REQUEST FOR INFORMATION	DATE: April 20, 2016	NO.: RFI-045
--------------------------------	-----------------------------	---------------------

Project Name: Webster University Interdisciplinary Science Building

Subject: Steel detailing questions

S0102

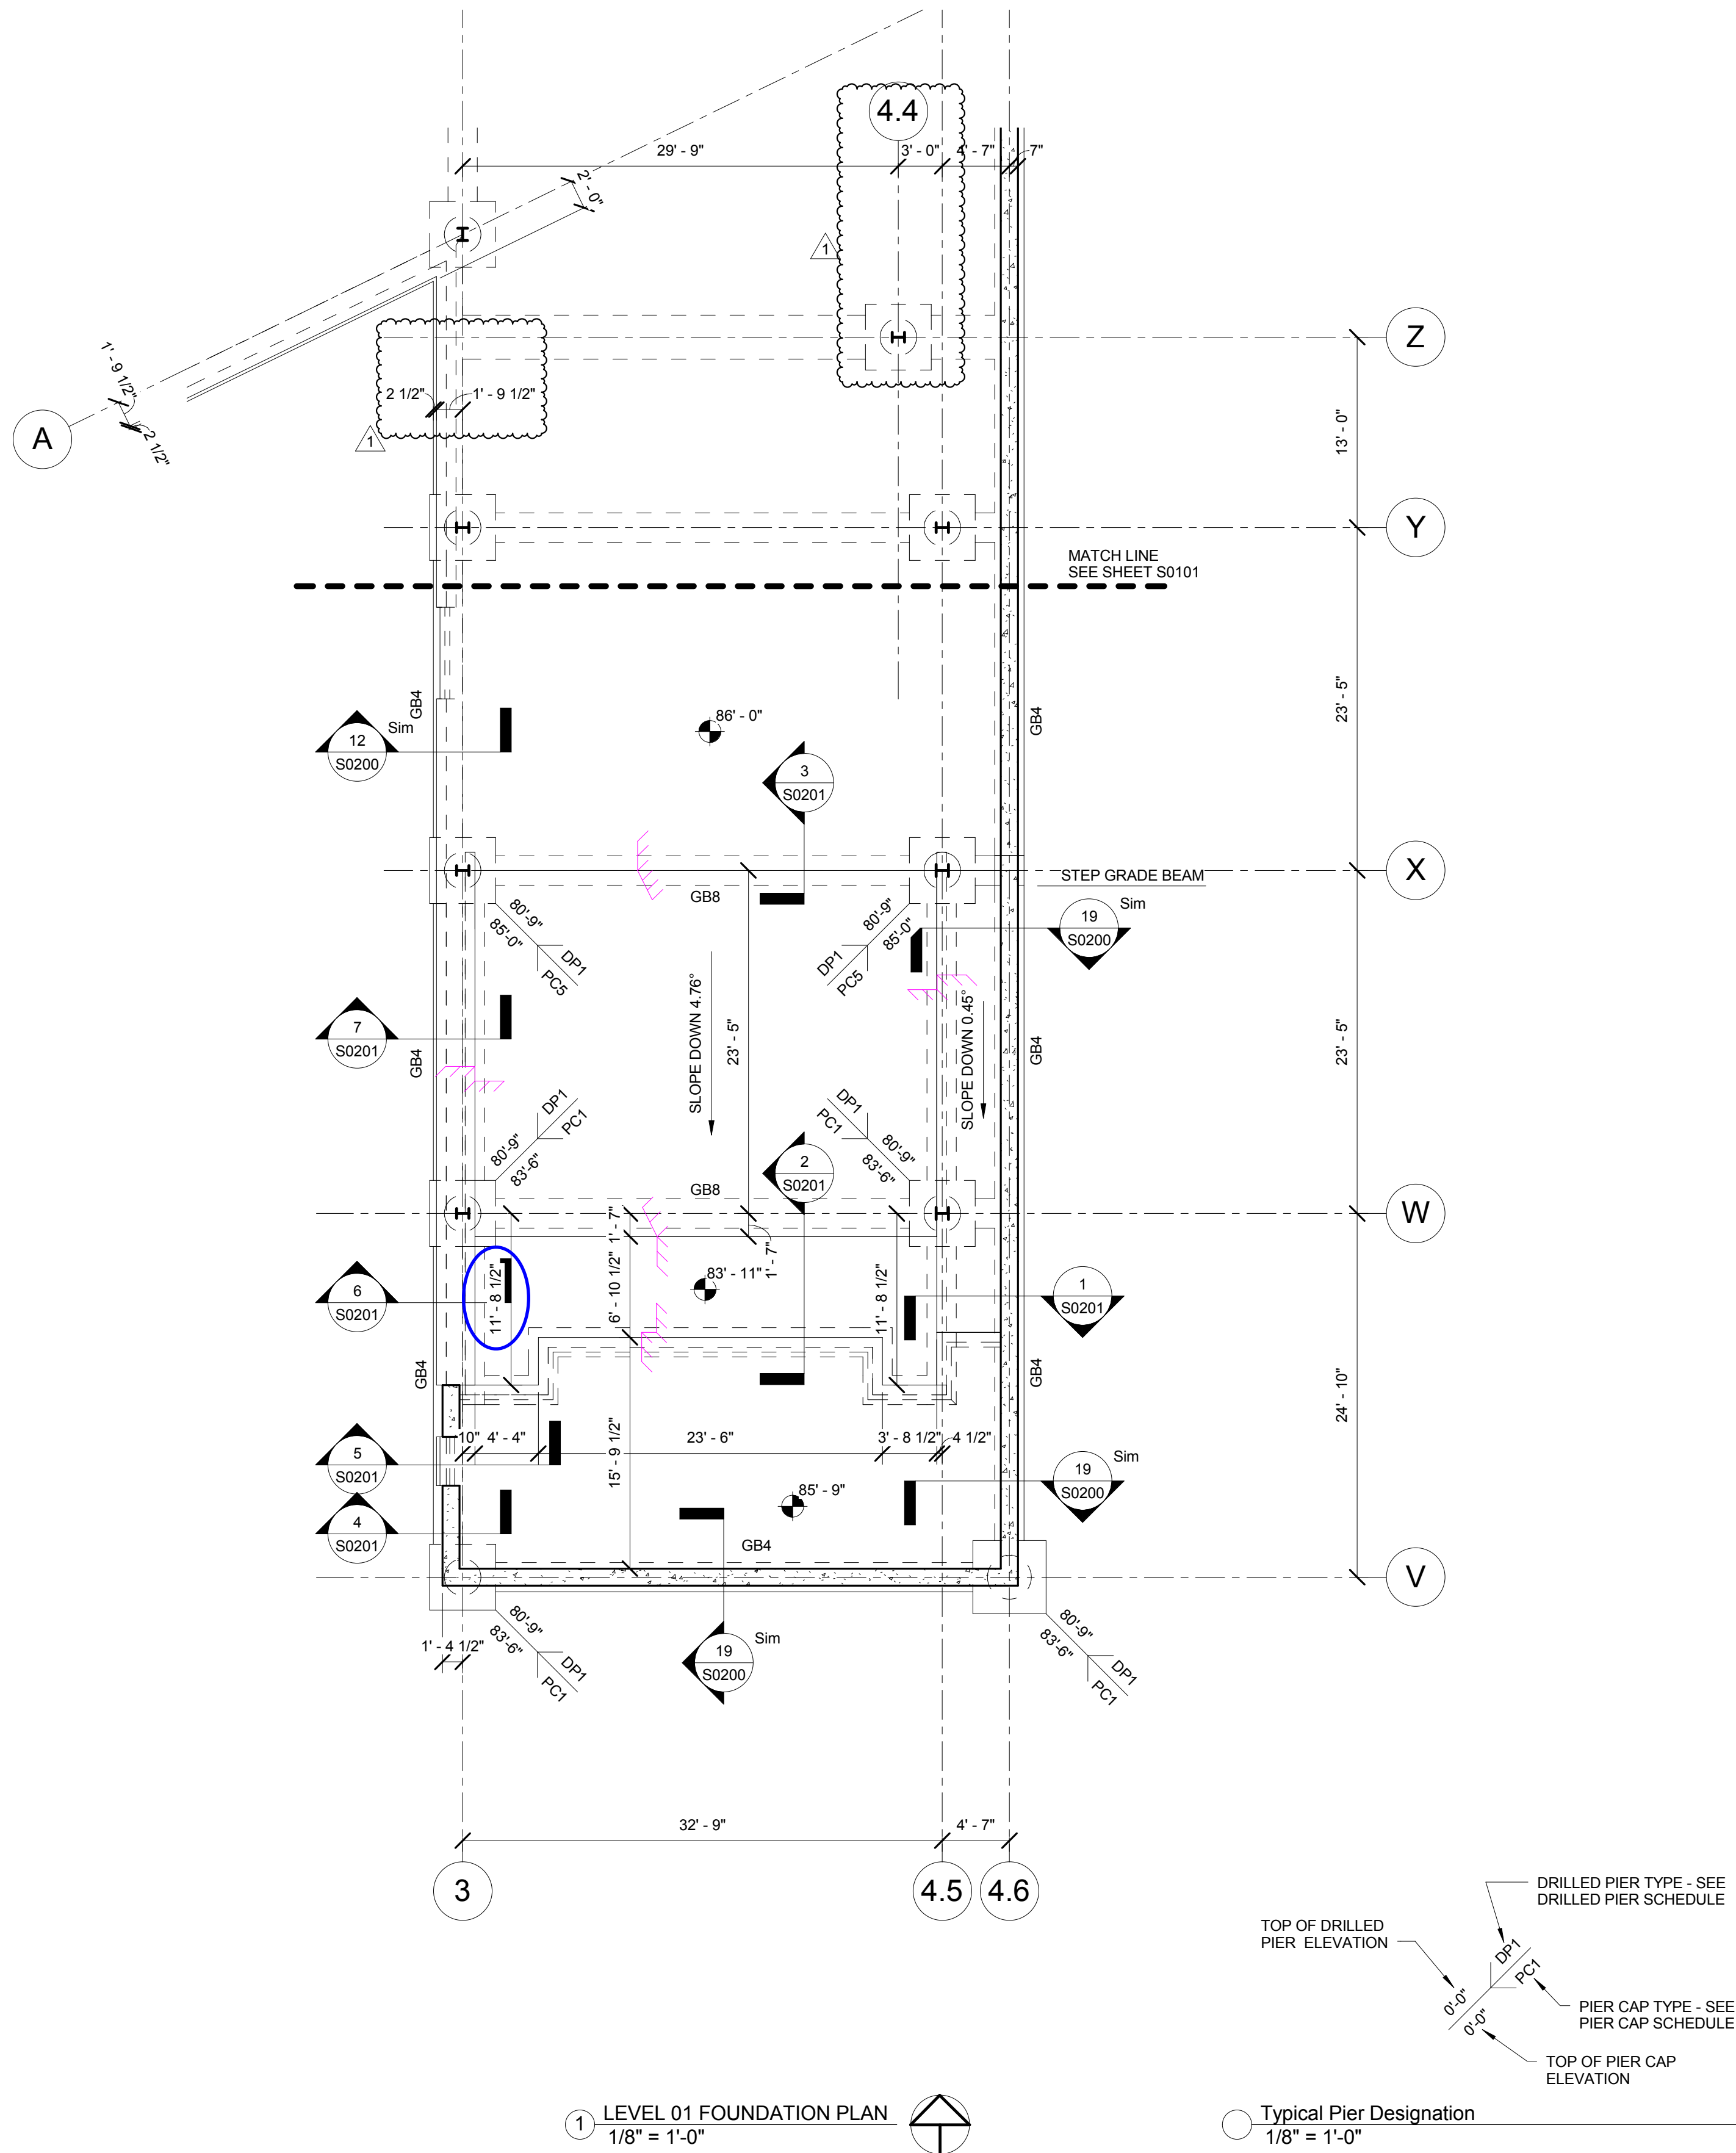
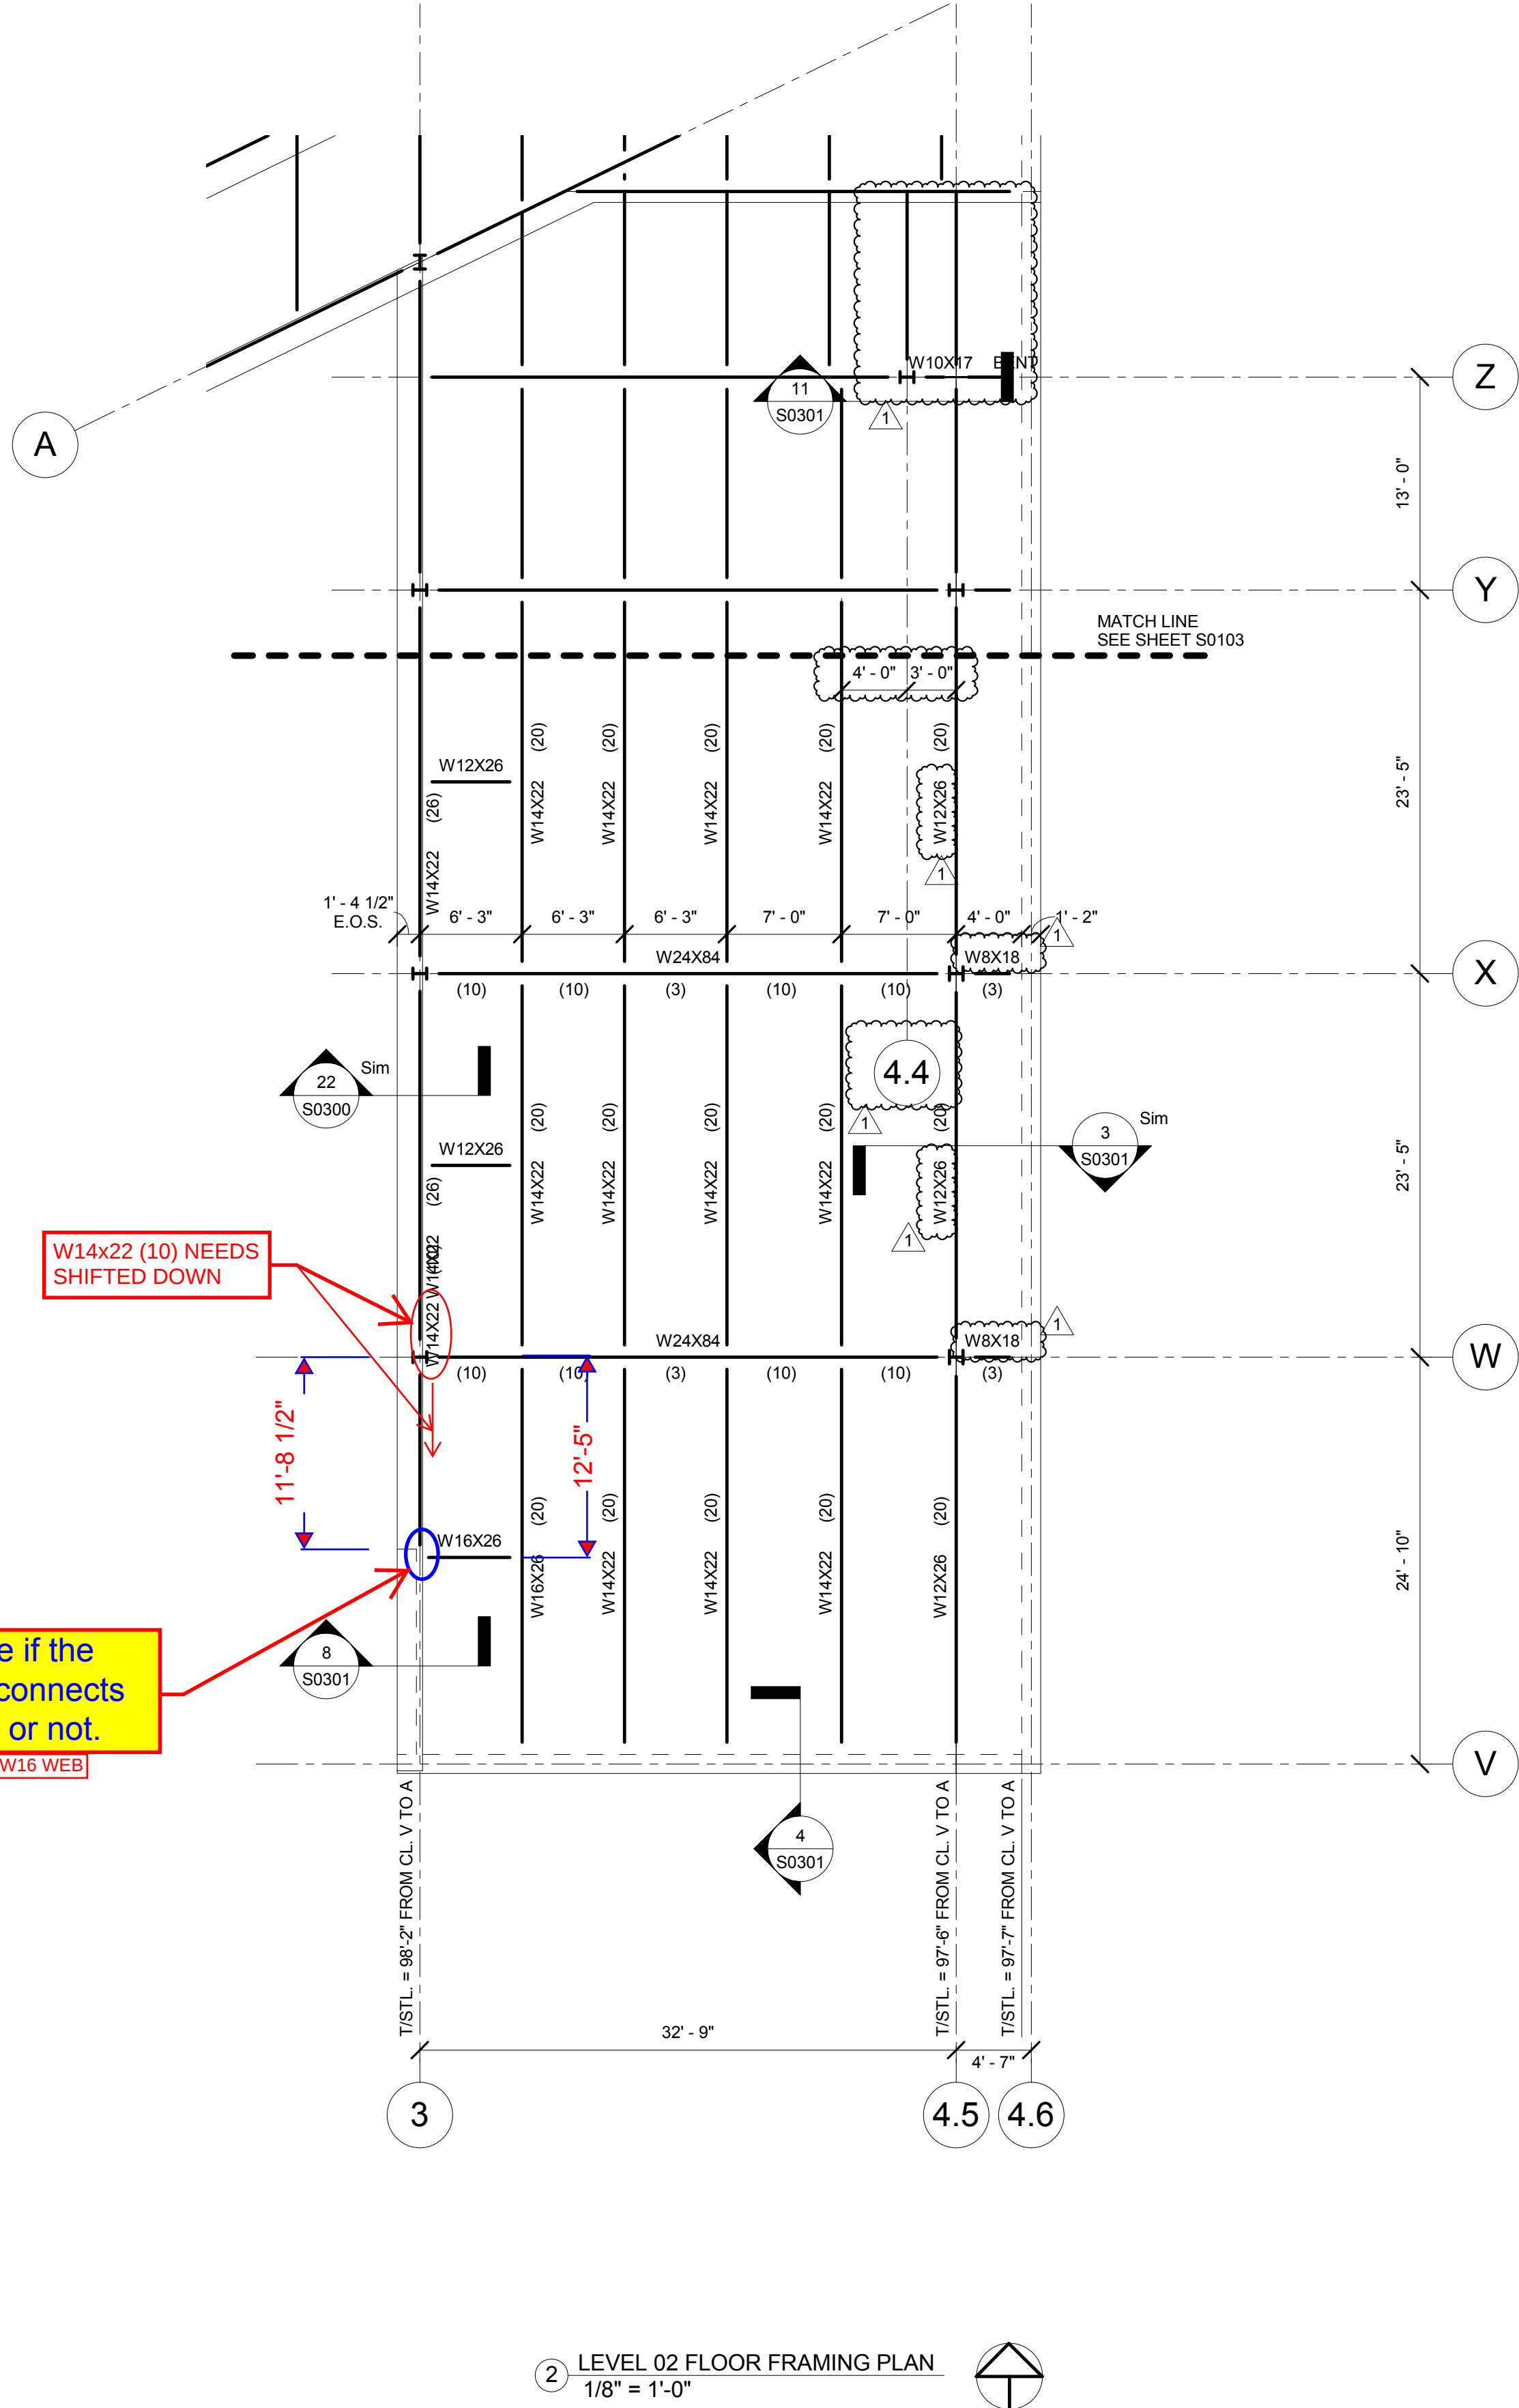
1. Please advise the dimensions between grid 7.3 and grid 8. See marked S0101.
2. Please clarify the elevation on top of pilaster @ B.3-6. See marked S0101 and S0501.
3. Please advise the connection. See marked S0102.
4. Please provide the dimension. See marked S0103.
5. Please provide the dimension. See marked S0103.
6. Please clarify the elevation. See marked S0103.
7. Please provide the dimension. See marked S0106.
8. Please provide the dimension. See marked S0107.
9. Please clarify the tube size. See marked S0107, S0304, and S0500.
10. Please clarify the detail. See marked S0106 and S0303.
